HARTING Product Change Notification	PCN
---	--	------------

Business Unit: Electric **PCN/18/011/C+N-US**

Title: Han 70A Module improvement of mating face

70A Female Axial Screw

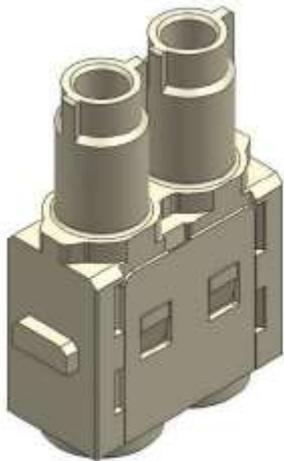
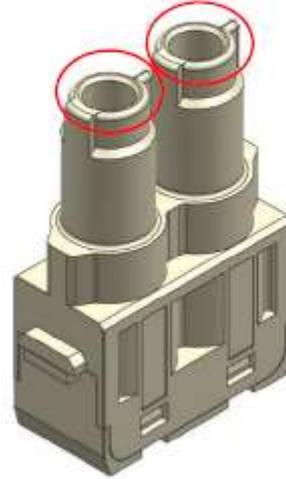
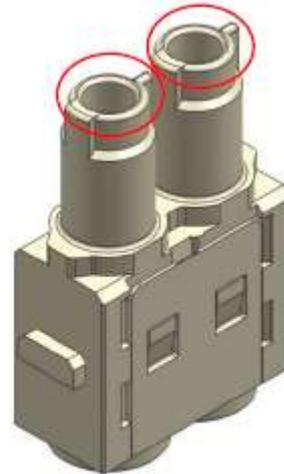
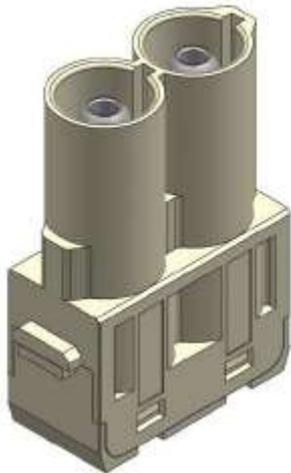
We have added chamfers to the mating face of the Han-Modular® 70 A Module and the Han® HV Single Module.

Also, to keep in-line with coding safety, coding fins have been enlarged.

The new chamfers and coding fins are marked red on the drawings shown below.

The new chamfers improve the mating process of the Han® 70 A Modules and Han® HV Single Modules. As a result, easier matings by hand and in combination with docking frames is realized.

The coding, which prevents incorrectly mating, is still a key feature of these modules. All modules, old and new versions, are mating compatible with each other.
